# Access Compliance Report

## Public Rights-of-Way

### (Curb Ramps)

Intersection ID: 2711	Main Street: FAIRWAY_POINT_DR	Cross Street: RAVENCREST_DR	Location: NE
ADA ID: 987DCE1EEE27	Ramp Type: BlendTrans1	Initial Pass/Fail: Fail	Overall Compliance: No
			Severity Score: 33.75

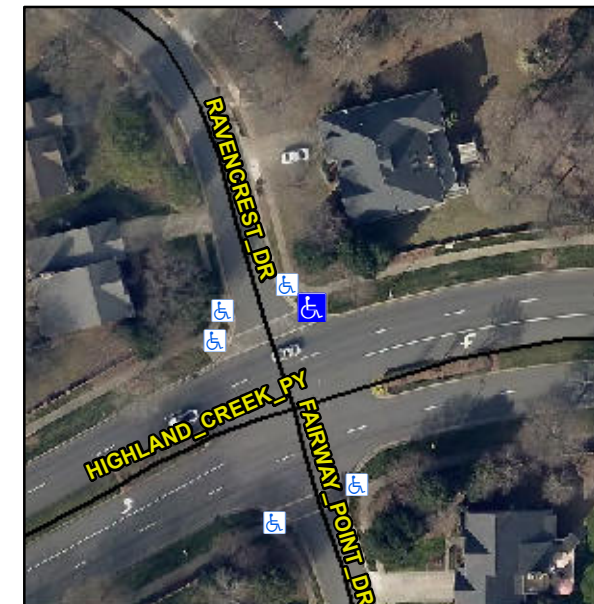
**GTR GAP 1.0**

**Not Found, R304.5.1, R304.5.3**

Compliance	Description	Data	Compliance	Description	Data
N/A	Ramp Length (in)	101.0	Yes	BlendTrans Slope (%)	0.6
No	Ramp Width (in)	36.0	No	BlendTrans XSlope (%)	9.2
N/A	Flare Type LT	N/A	N/A	Flare Type RT	N/A
N/A	Flare Slope LT (%)	N/A	N/A	Flare Slope RT (%)	N/A
N/A	Flare Traversable LT?	N/A	N/A	Flare Traversable RT?	N/A
N/A	Landing Length (in)	N/A	N/A	DWS Provided?	N/A
N/A	Landing Width (in)	N/A	N/A	DWS Contrast?	N/A
N/A	Landing Slope (%)	N/A	N/A	DWS Length (in)	N/A
N/A	Landing X Slope (%)	N/A	N/A	DWS Full Width?	N/A
N/A	Landing Curb? (Y/N)	N/A	N/A	DWS Offset (in)	N/A
N/A	Shared Landing?	N/A			
N/A	Gutter Ponding?	N/A	N/A	Gutter Slope (%)	N/A
N/A	Gutter Lip Ht (in)	N/A	N/A	Gutter X Slope (%)	N/A
N/A	Painted X Walk1?	No	N/A	Painted X Walk2?	No
	X Walk 1 Direction	To W		X Walk 2 Direction	To S
	X Walk 1 Width (in)	N/A		X Walk 2 Width (in)	N/A
	X Walk 1 Slope (%)	4.7		X Walk 2 Slope (%)	2.4
	X Walk 1 X Slope (%)	5.1		X Walk 2 X Slope (%)	6.8

N/A	Ramp inside XWalk1?	N/A	N/A	Ramp inside XWalk2?	N/A
	Road Slope (%)	8.8		Clear Space?	N/A
	Road X Slope (%)	0.1	N/A	Clear Space to XWalk (in)	N/A
N/A	Any Obstructions?	N/A	N/A	Storm Grate/Utility Hazard?	N/A
	Obstruction Type			Storm Grate/Utility Type	
		N/A			N/A
			Yes	Surface Condition? (G/P)	Good
			No	Curb Slope (%)	22.0

**Remove & Replace Curb Ramp With Two New Directional Ramps or Equivalent.**
